**STAFF RECOMMENDATION**  
**1112 Forrest Avenue**  
**October 17, 2012**

**Application:** Demolition  
**District:** Lockeland Springs-East End Neighborhood Conservation Zoning Overlay  
**Council District:** 06  
**Map and Parcel Number:** 08309012000  
**Applicant:** Tim Wesley  
**Project Lead:** Robin Zeigler, robin.zeigler@nashville.gov

**Re: Review of Structural Integrity of  
Residence for Remodeling  
1112 Forrest Avenue  
Nashville, TN 37206  
AJDS Project No. 12-0826-000**

Re: Structural Observations of Framing  
Residence, 1112 Forrest Ave., Nashville

## EXISTING PLAN OF RESIDENCE

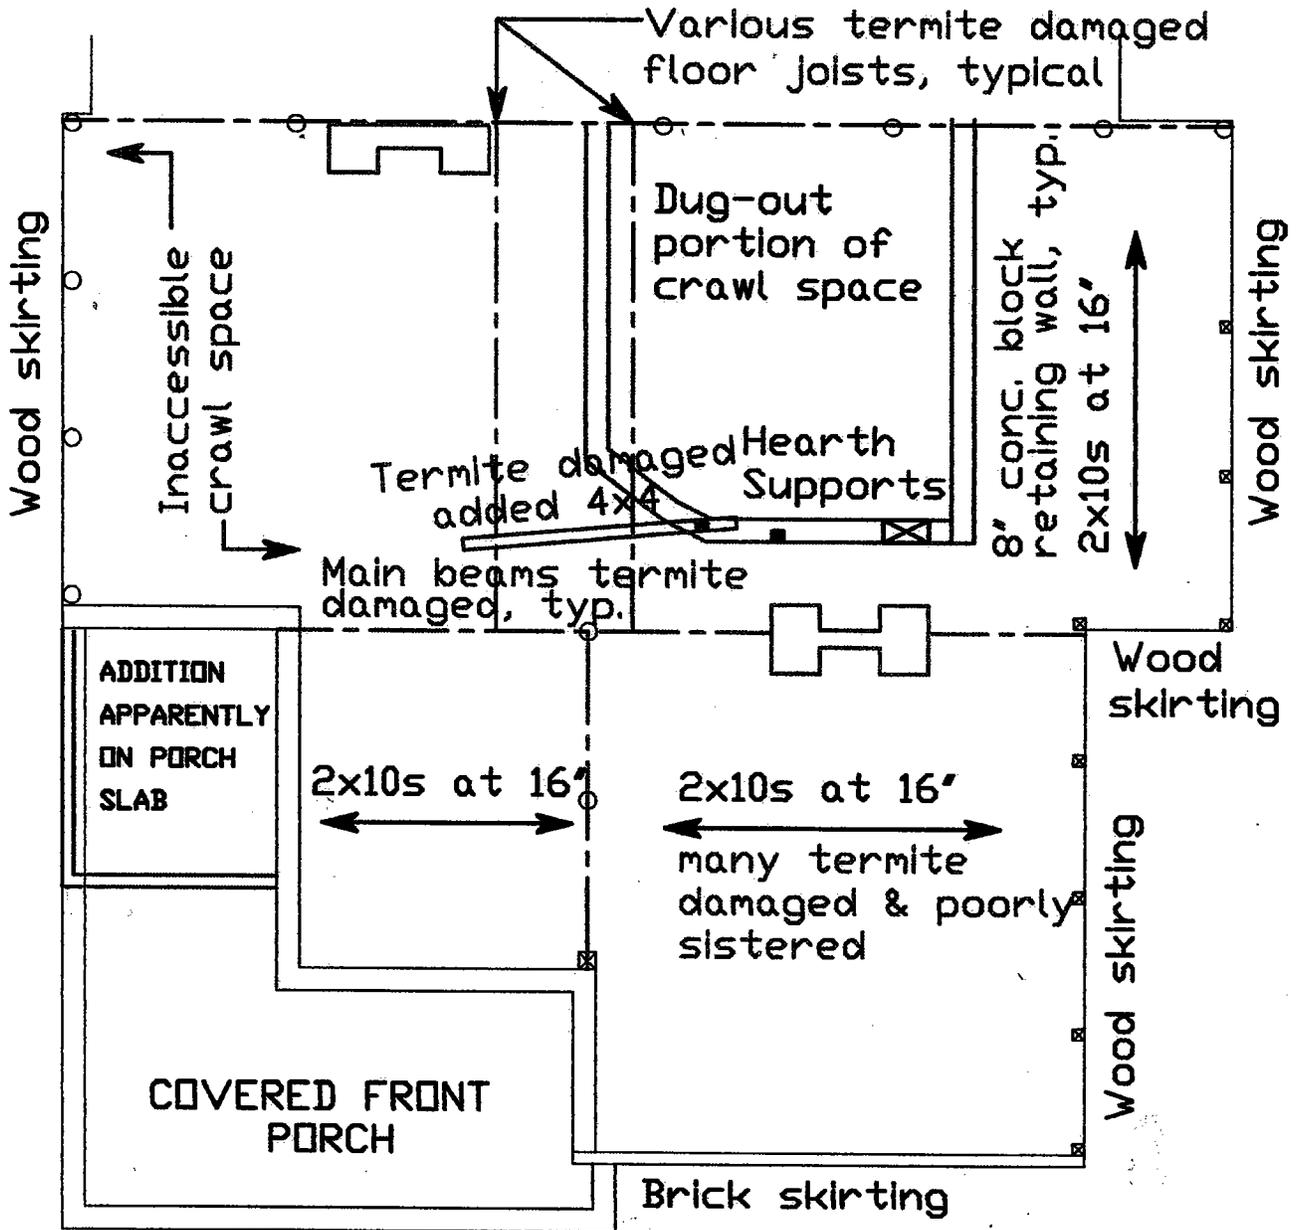
As noted on the attached sketch and in the remainder of this report, we feel that the original front portion of the residence also needs to be demolished and the whole

1. Although not first noted in the architectural drawings, the only section of the residence with brick skirting is at the right front as shown on the attached sketch. The remainder of the skirting for the residence is wood. The support of the residence both interior and at the exterior walls is by wood posts placed in the ground. Both the wood skirting and the wood posts have suffered both termite damage and rot damage so they are in need of replacement. The wood skirting would not be difficult to replace, but it would not be feasible to replace the wood posts as the house would need to be temporarily supported by a house mover and then a new foundation constructed under the residence.
